MITIGATION PLAN

Final Report for IRT

HUNTSMAN MITIGATION SITE

Subject: Mitigation Plan Report and Construction Plans
Huntsman Mitigation Site, Wilkes County
Yadkin River Basin – CU# 03040102
DMS Project ID #100123
USACE #SAW-2019-00836

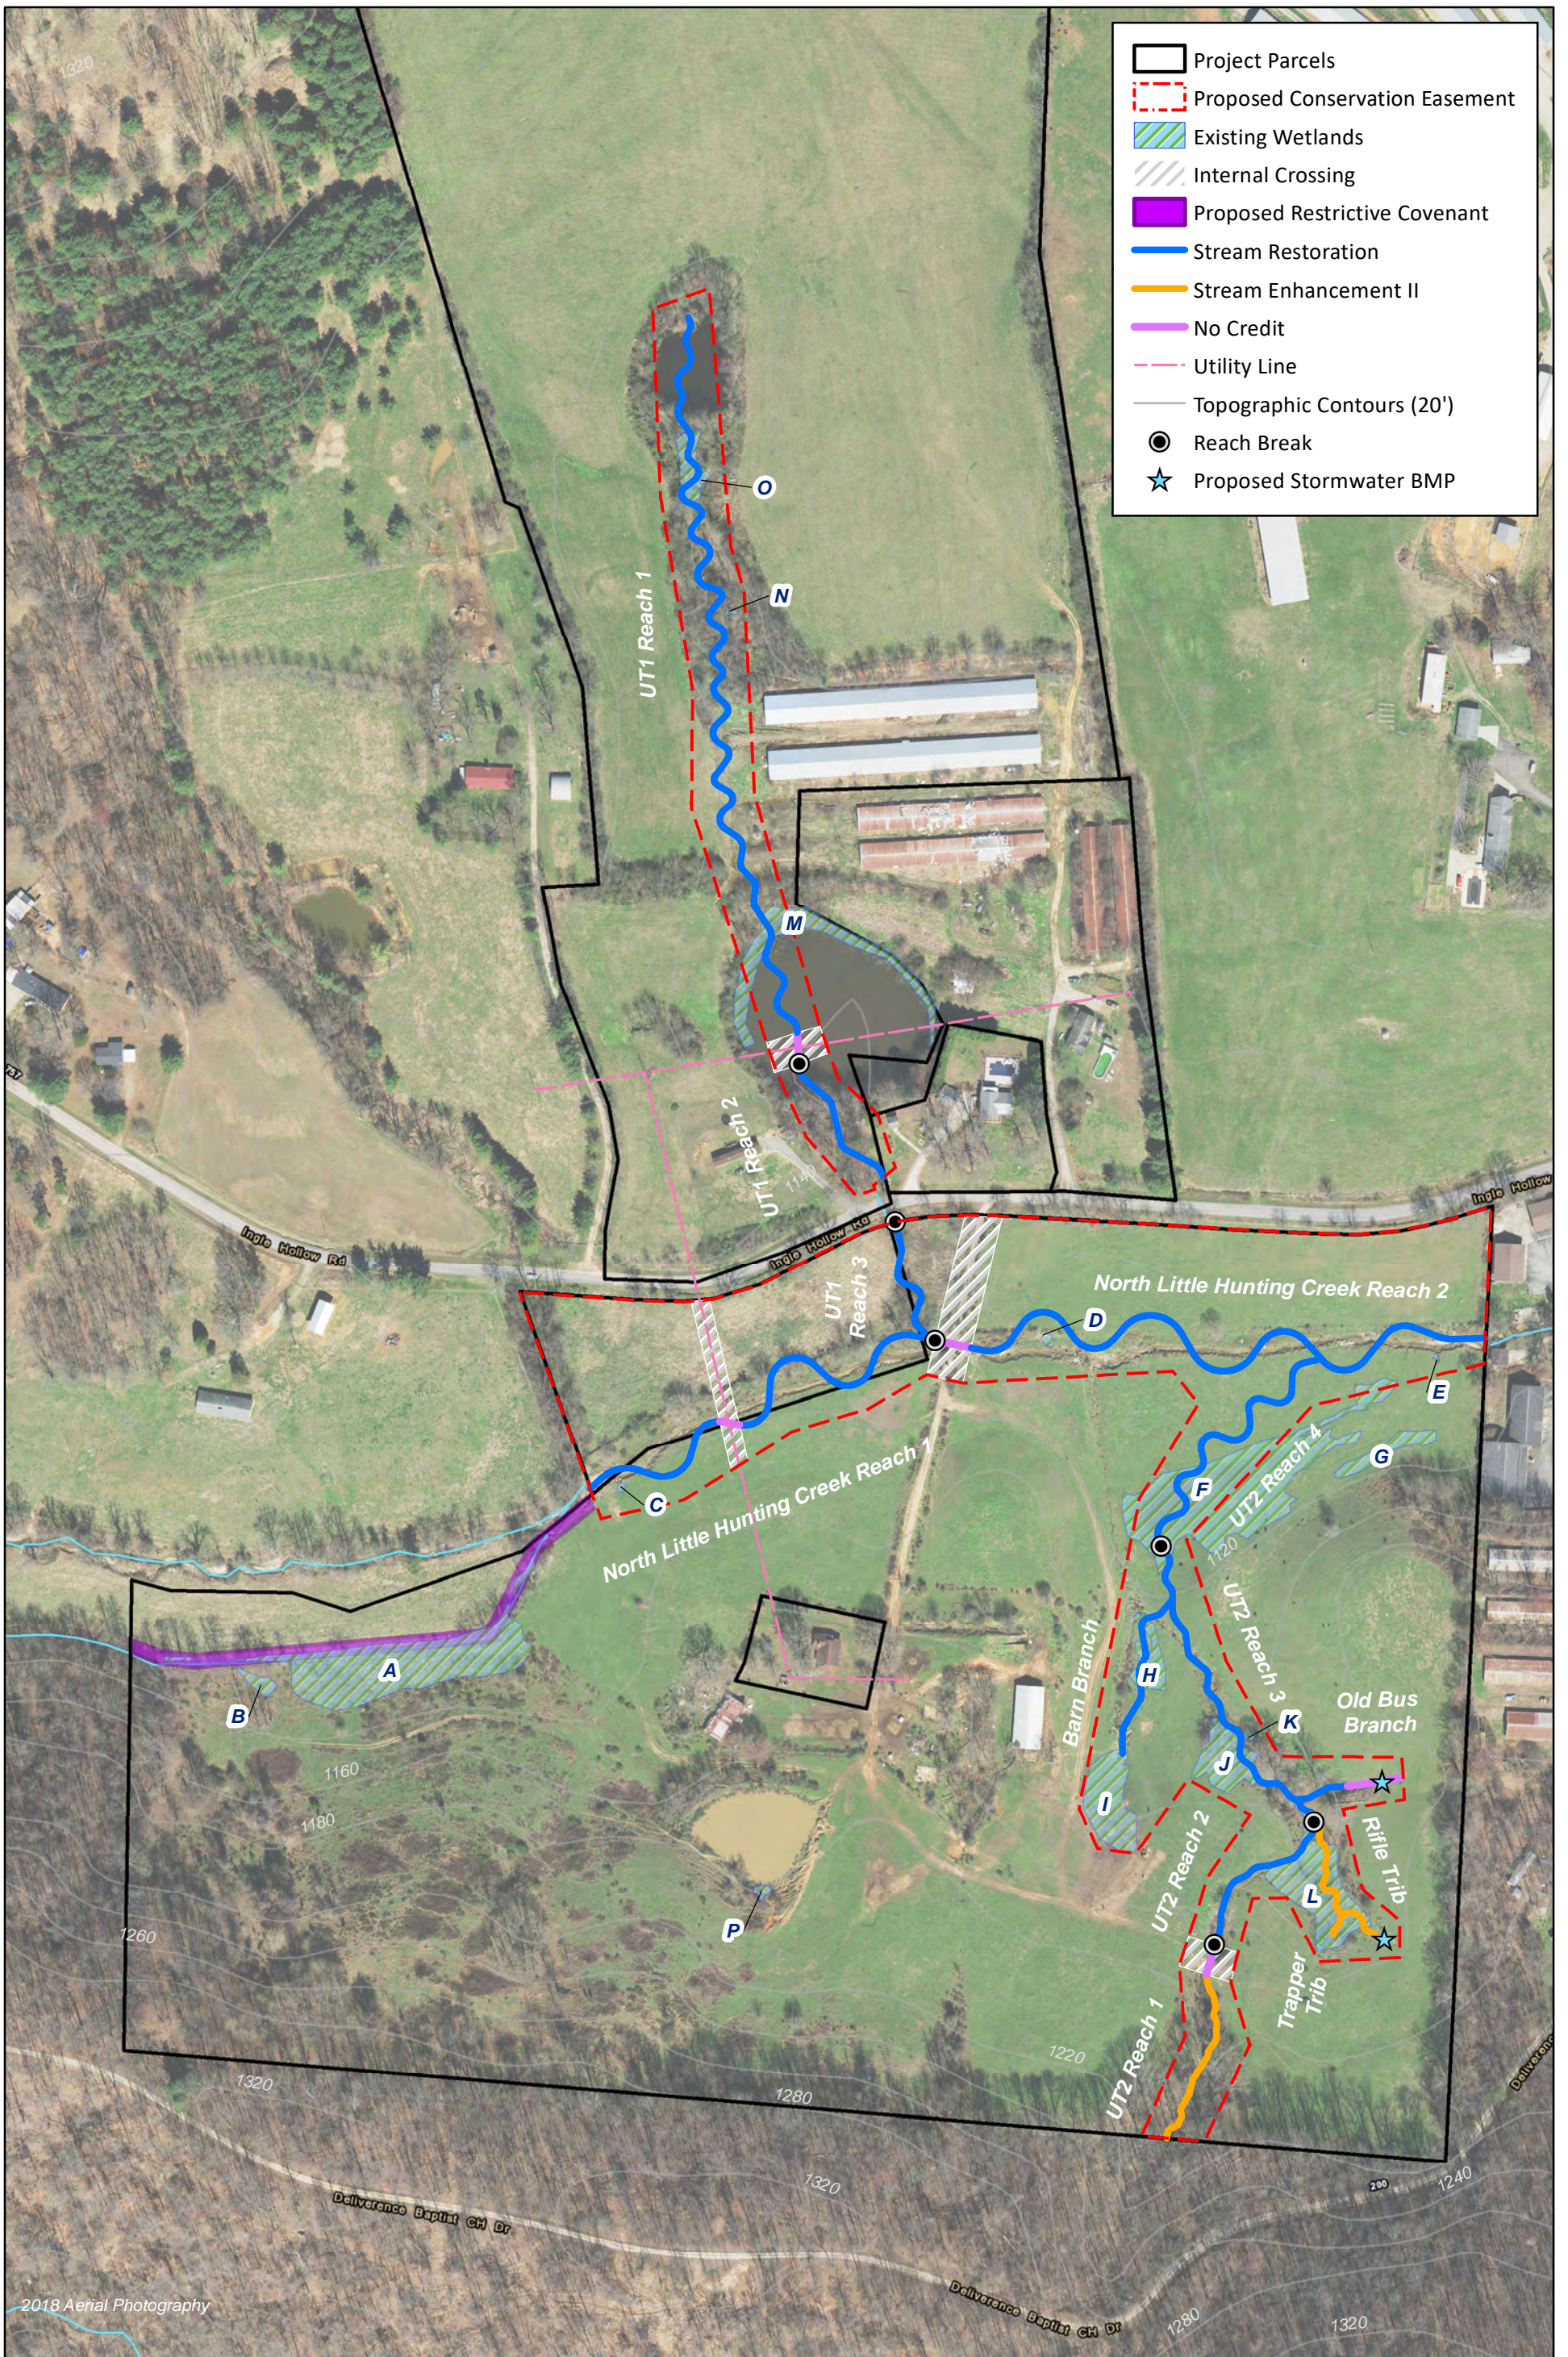
- 7) Figure 8 – It appears that the easement area along the floodplain south of North Little Hunting Creek (more so along Reach 2) was reduced from what was shown in the technical proposal. Please provide an explanation. With an approx. 2 sq. mile drainage area, the additional floodplain protection would have enhanced the functional uplift along the reach. Ideally, the easement would have captured the floodplain out to the FEMA line shown on Sheet 3.1.

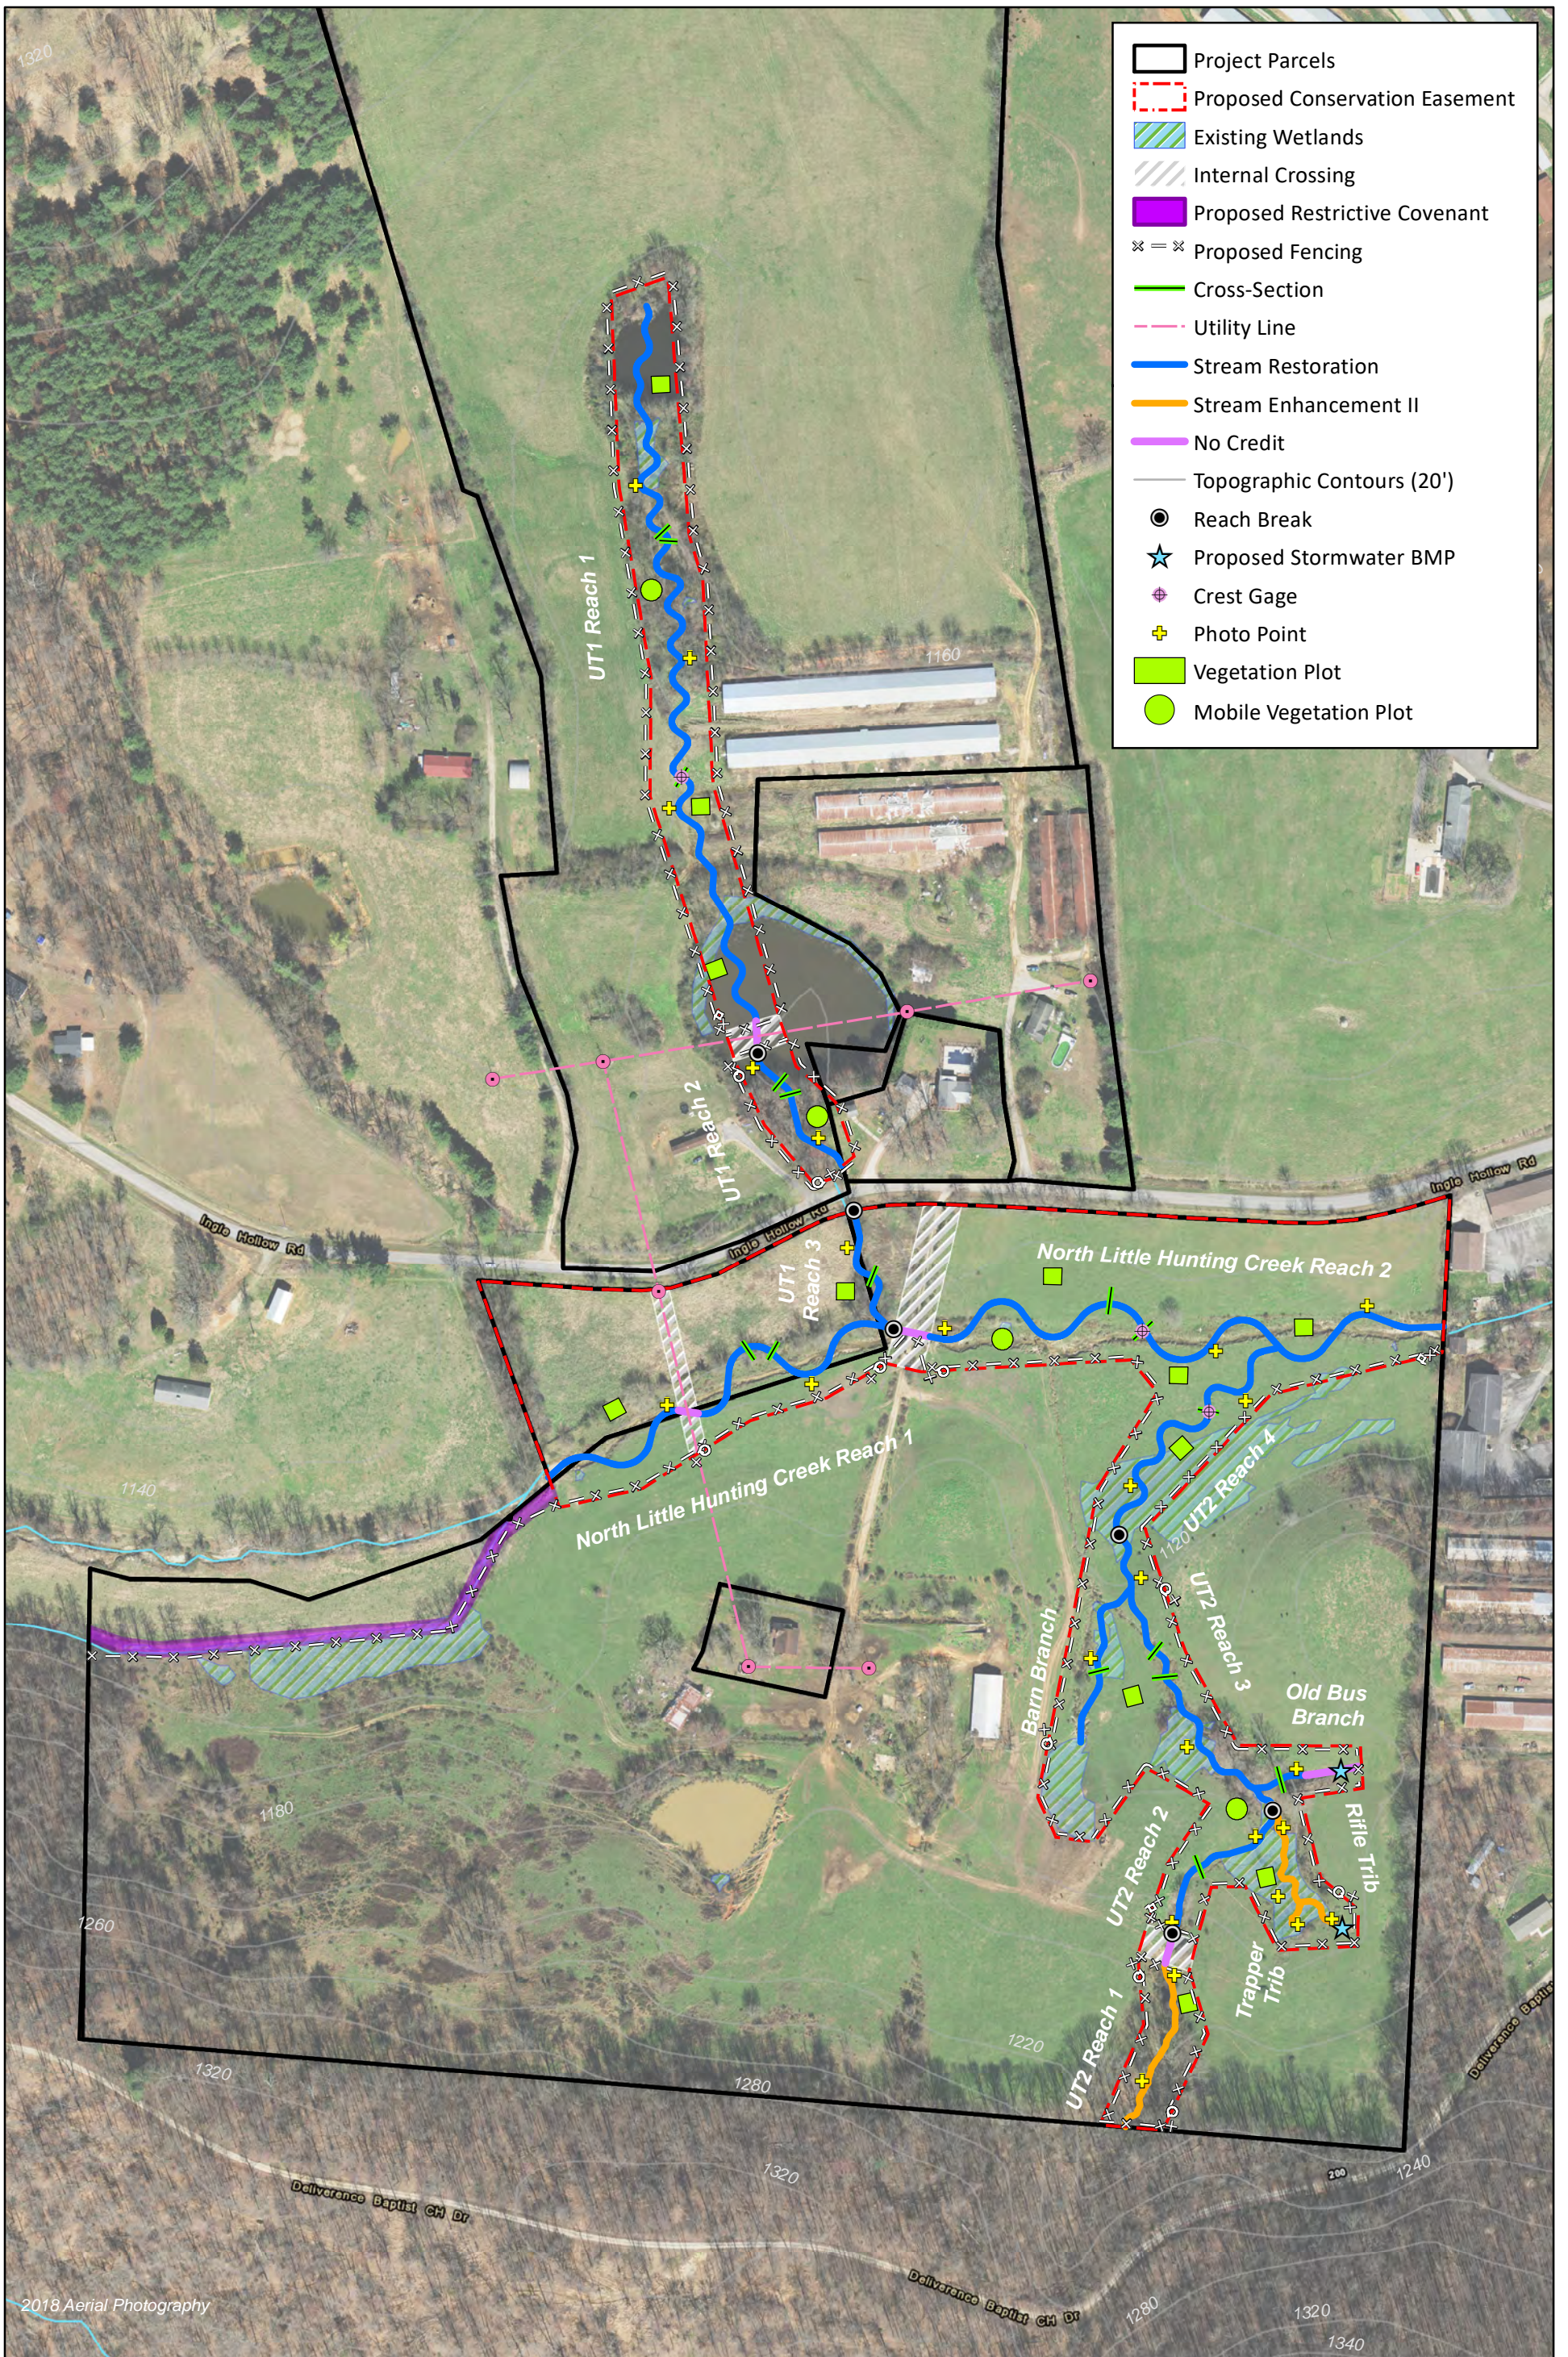
- 1) Figure 9: The legend shows a stream gauge but I cannot locate it on the map.
 - a) All streams proposed for work are perennial, so no stream gages are proposed. The legend has been corrected.**

- 2) Figure 9: Please place a veg plot north of North Little Hunting Creek Reach 2, south of Ingle Hollow Road, in the steeper area near the road (the FcC2 soils)—random is fine.

- 8) Figure 9 – DWR requests one additional permanent veg plot in the floodplain north of North Little Hunting Creek Reach 2.
 - a) **An additional veg plot was added in the requested area. Please see the updated Figure 9 and Table 26.**

- a) An additional veg plot was added in the requested area. Please see the updated Figure 9 and Table 26.**
- 3) Design Sheet 4: There is a Note under the Open Riparian Buffer Planting Zone that indicates that optional transplants to be used at Engineer's discretion. If this occurs and the transplant species differ from those on the approved planting list, please red-line this as a change to the planting plan on the As-Built. You may contact WRC/USACE for species appropriateness.
